Project
MMU SCIENCE AND ENGINEERING BUILDING
RF20-823

Document title
OVERALL SITE PLAN

Drawing number
13388-RFM-NB-00-DR-L-0011

Changes Following Stage 4 Design

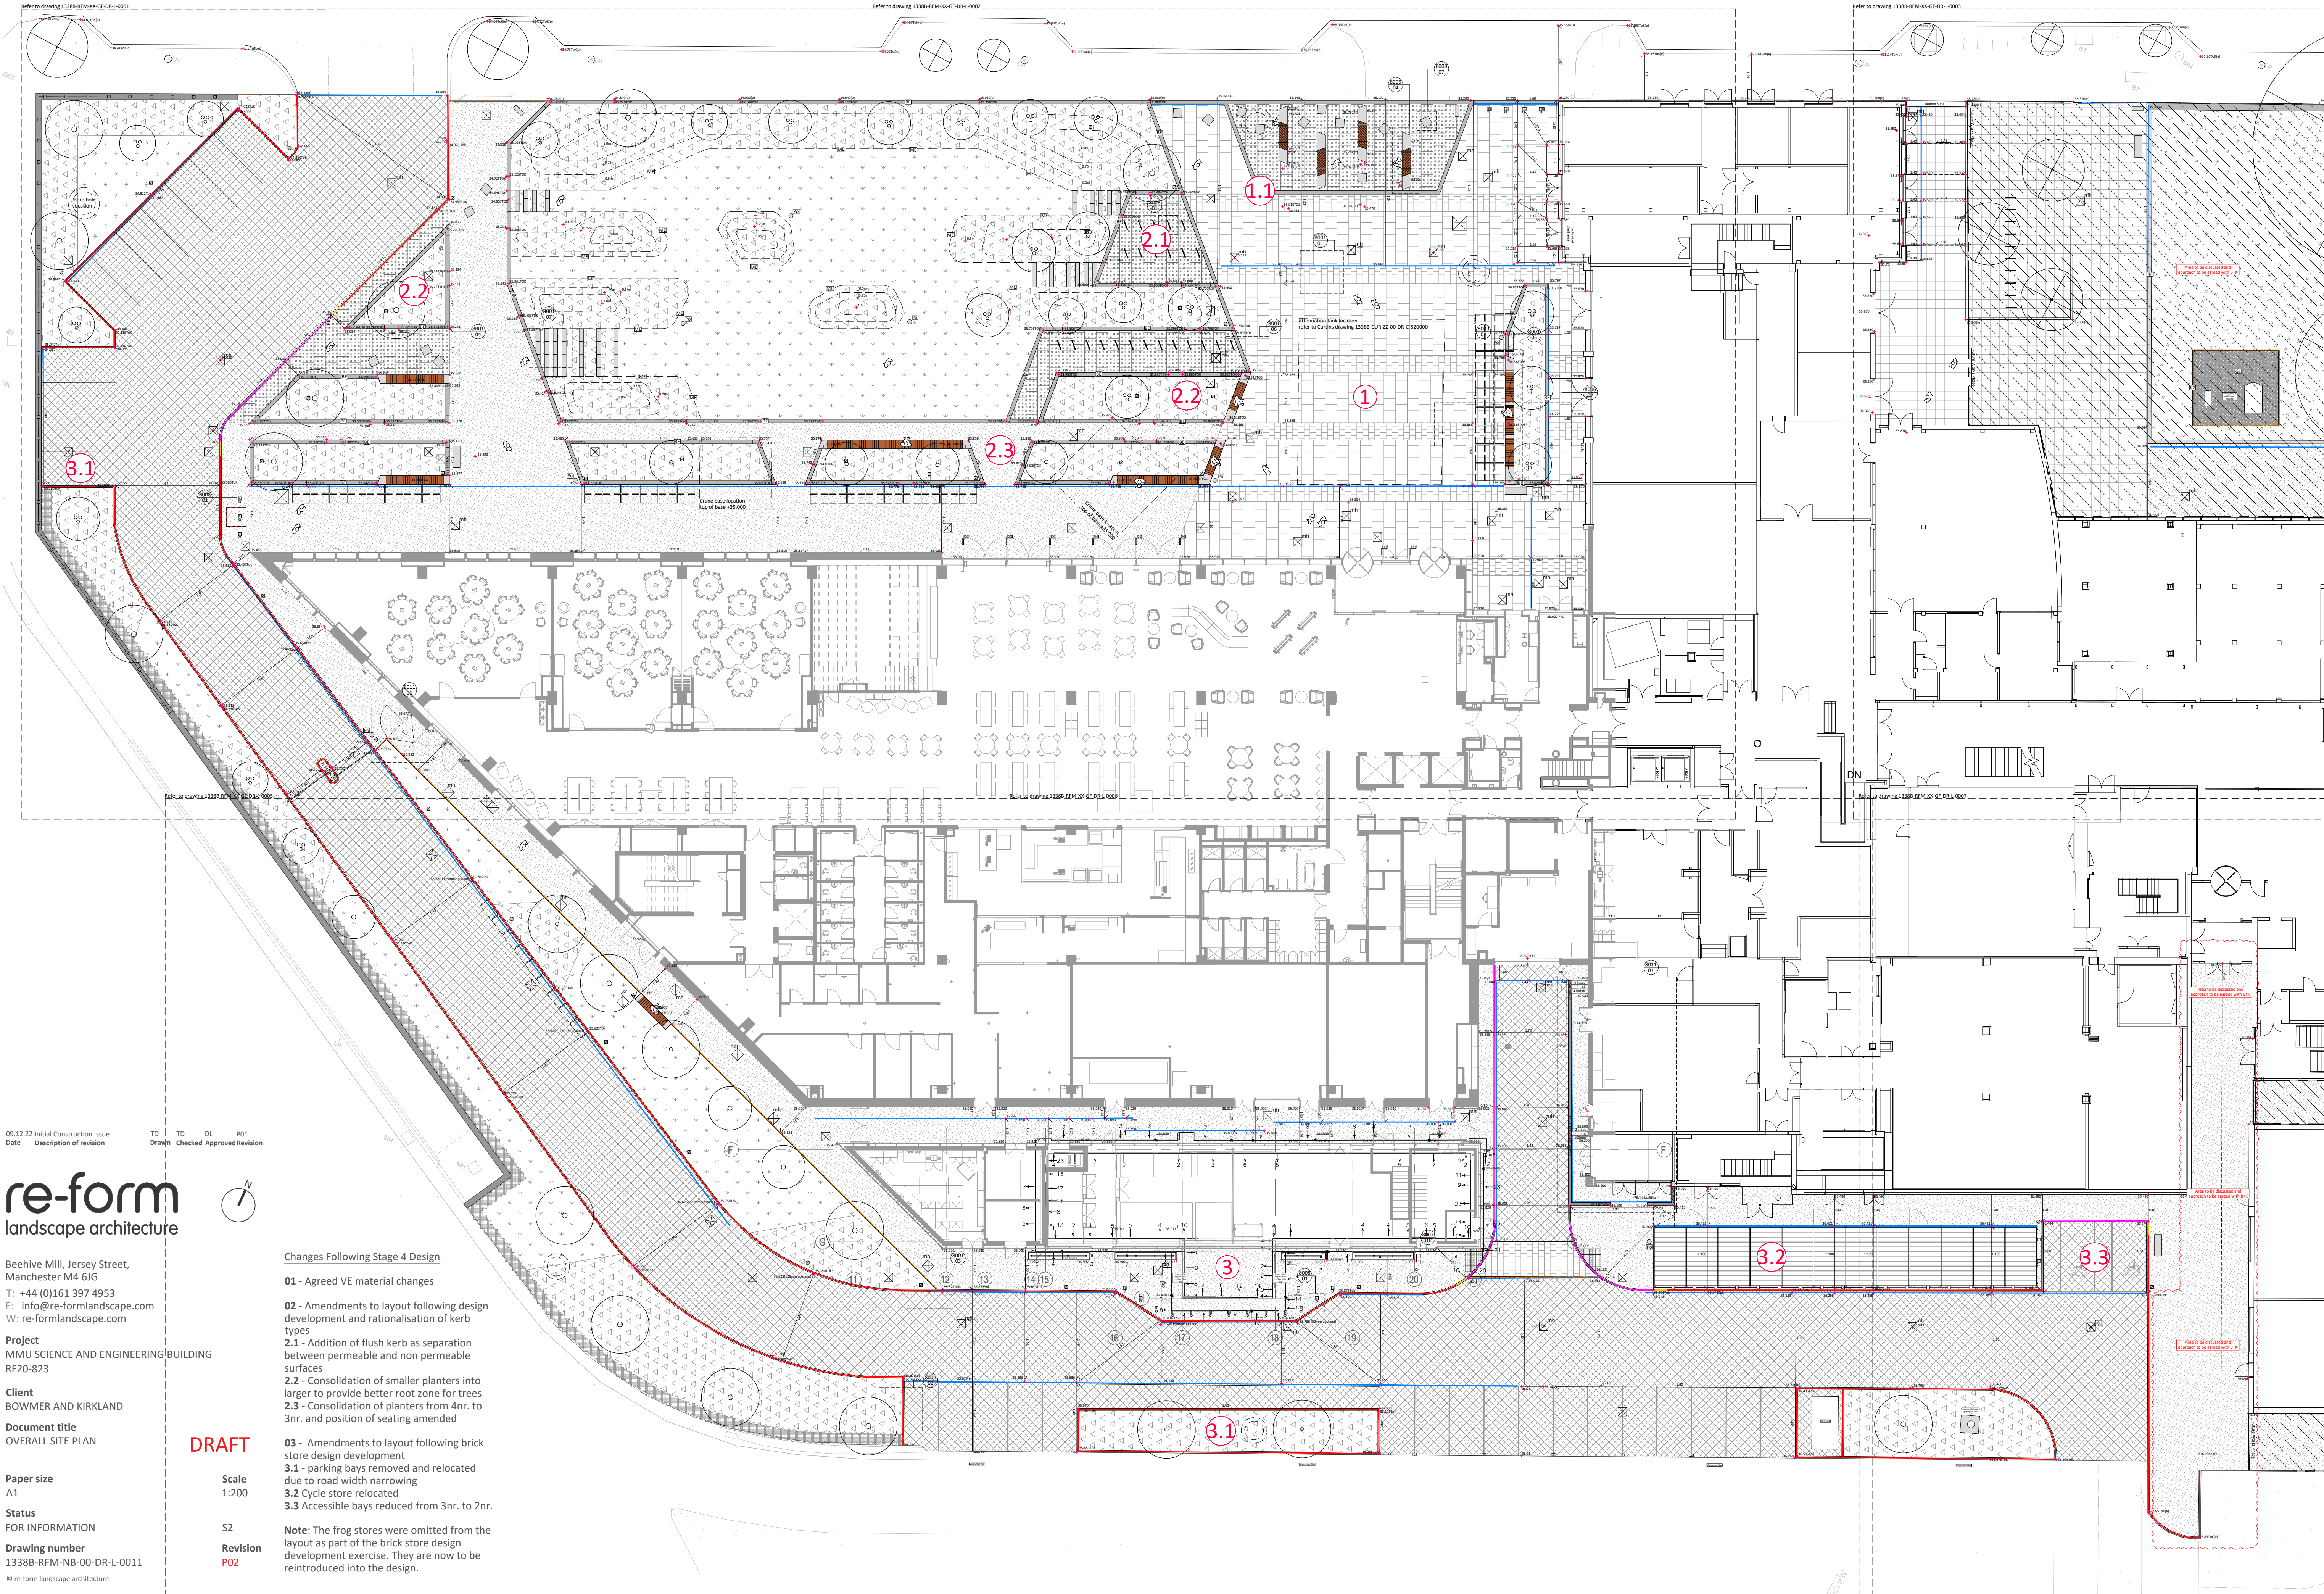
- 01 - Agreed VE material changes
- 02 - Amendments to layout following design development and rationalisation of kerb types
- 2.1 - Addition of flush kerb as separation between permeable and non permeable surfaces
- 2.2 - Consolidation of smaller planters into larger to provide better root zone for trees
- 2.3 - Consolidation of planters from 4nr. to 3nr. and position of seating amended
- 03 - Amendments to layout following brick store design development
- 3.1 - parking bays removed and relocated due to road width narrowing
- 3.2 Cycle store relocated
- 3.3 Accessible bays reduced from 3nr. to 2nr.
- Note: The frog stores were omitted from the layout as part of the brick store design development exercise. They are now to be reintroduced into the design.
